Declaration Letter

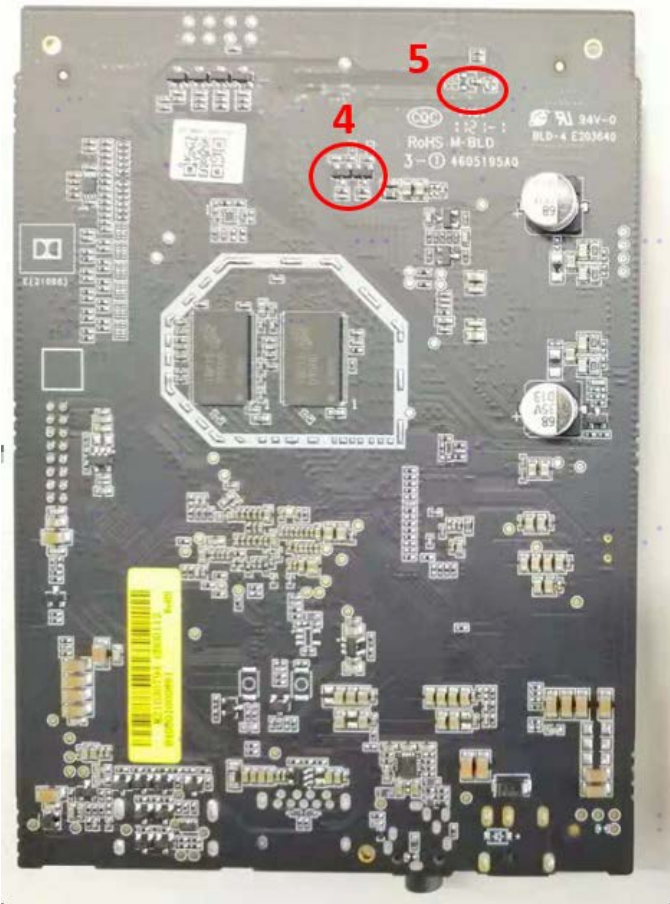
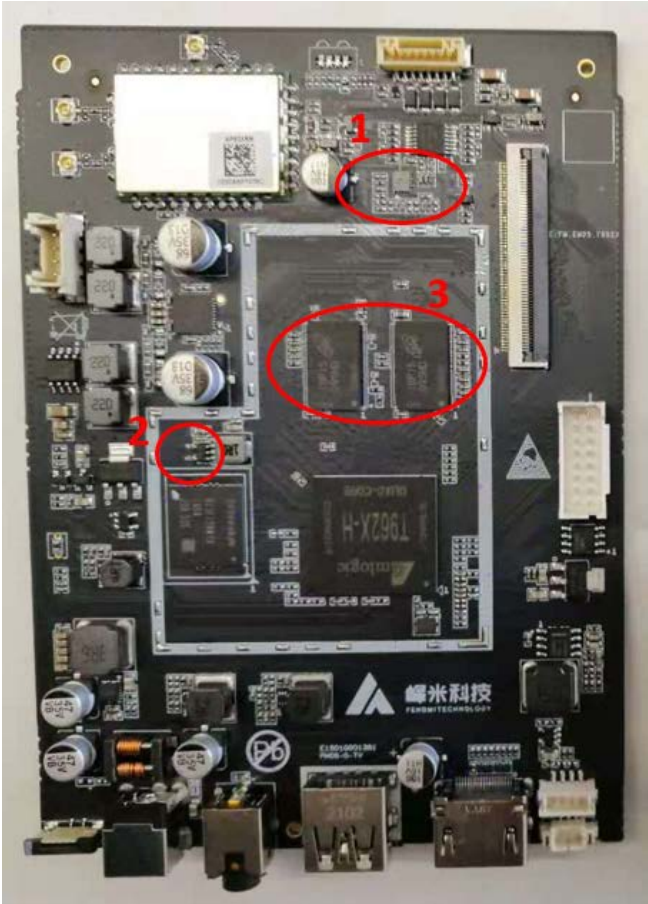
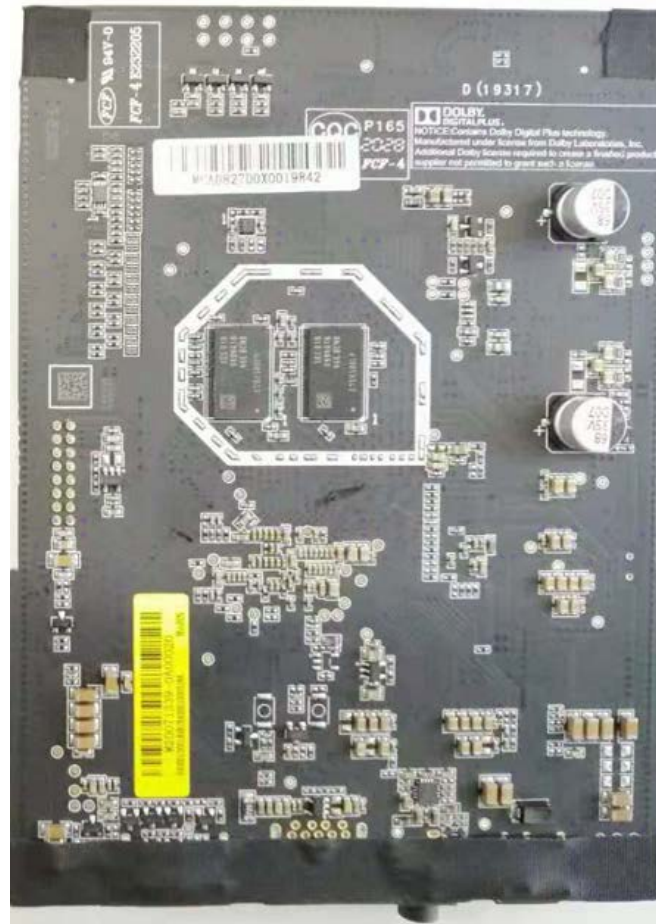
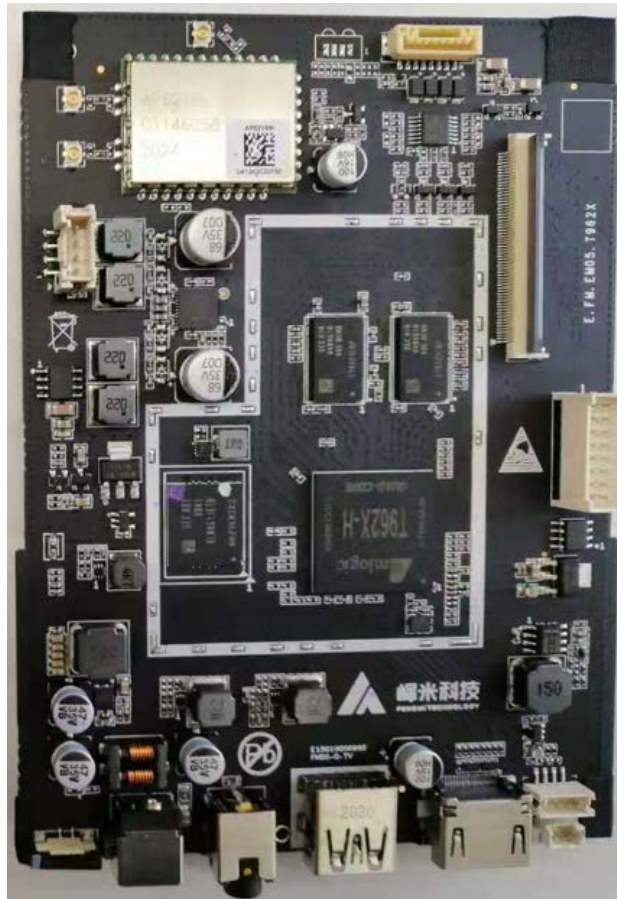
Difference items	Previous board	Updated board
Highlight 1/4/5	Updated the PCBA design for compatible with different specification Gsensor components.	
Highlight 2	Updated the PCBA design for compatible with different specification DC-DC chipset.	
Highlight 3	MICRON Brand DDR replace of the Samsung Brand DDR.
